Technical Service Bulletin: TSB120143

New Valve Guides

This document announces the release of new valve guides for the cylinder heads installed on the QSK19 CM500 HPI, QSK45/60 CM500 HPI, QSK60 CM850 MCRS, and QSK60 CM2150 MCRS engines.

Figure 1

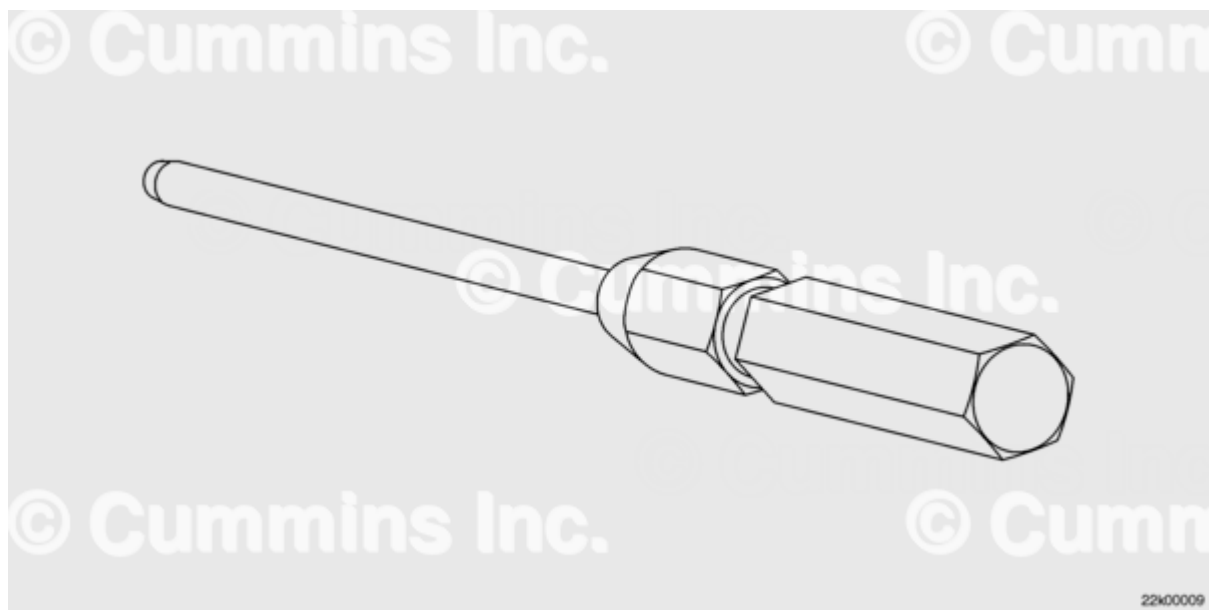
A drop gauge test has always been required following valve guide installation into the cylinder head. A new drop gauge is required to make sure that the improved valve guide internal diameter tolerance is maintained following installation of the guide into the cylinder head. The new drop gauge has an increased diameter.

Required Items		
	Old Part Number	New Part Number
Drop Gauge (Figure 1)	4918779	5298508
Reamer (Figure 2)	N/A	5298510

Figure 2

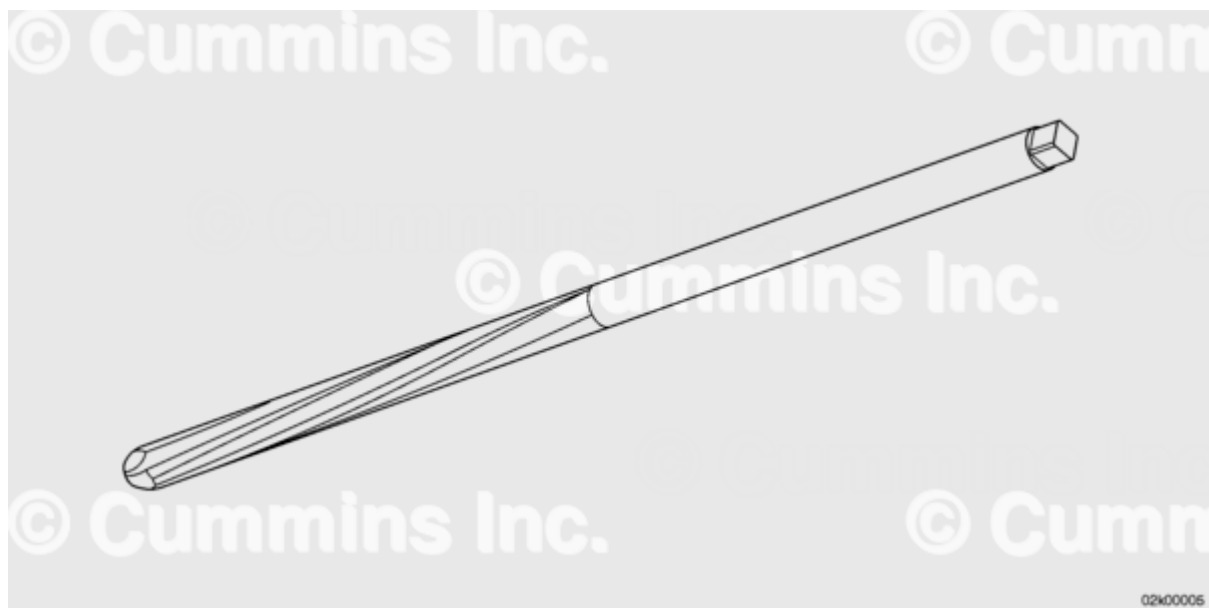
A new reamer has also been released, to avoid the requirement to remove and replace valve guides due to the drop gauge test **not** passing. The reamer is **only** to be employed following an unsuccessful drop gauge test.

When a valve guide is pressed into the cylinder head, some slight distortion to the internal diameter of the valve guide can occur. The purpose of the reamer is to remove a very small amount of material from any areas of distortion in the internal diameter of the installed valve guide. This makes sure the correct internal diameter is maintained and allows the drop gauge test to be successful.
